Re: Trapnell Orthodontics

Grading and Drainage Plan

Based upon the information provided in your submittal received 5/19/2016, the above referenced Certification received is acceptable for the release of Certificate of Occupancy by Hydrology.

TRAPNELL GRADING

09-24-2013 SHEET NUMBER CG-101

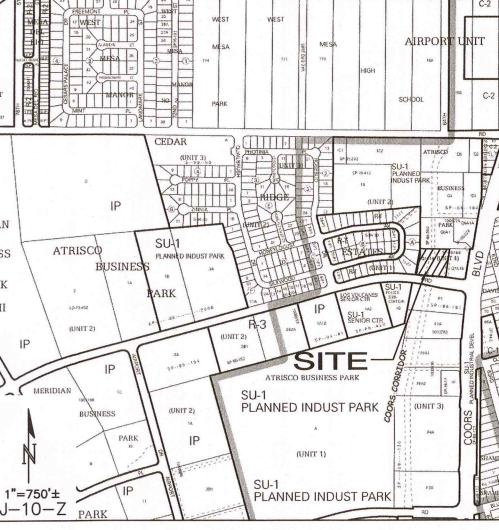
I visited the site this AM and I have one question. Note #5 states that the retaining wall is to have vertical gaps along the row of blocks at the top earth grade. These openings are missing. Will the site drain sufficiently without these openings?

The existing asphalt swale on the east side of the site was too degraded to function (per keyed note 3). Instead, the perimeter wall was moved west and a monolithic concrete swale was

2. The trench drain was eliminated, and replaced with a rock swale and curb opening. This change is acceptable.

I hadn't thought to look at those. Good catch. Because of the final landscaping in the courtyard and the fact that it's only water that falls in the courtyard that affects the ponding back there, I don't think it'll be a problem for flooding of the building.

Holes to relieve hydrostatic pressure behind retaining walls are always a good idea, though. I'll ask the contractor to put a few 4" PVC pipes through the wall.
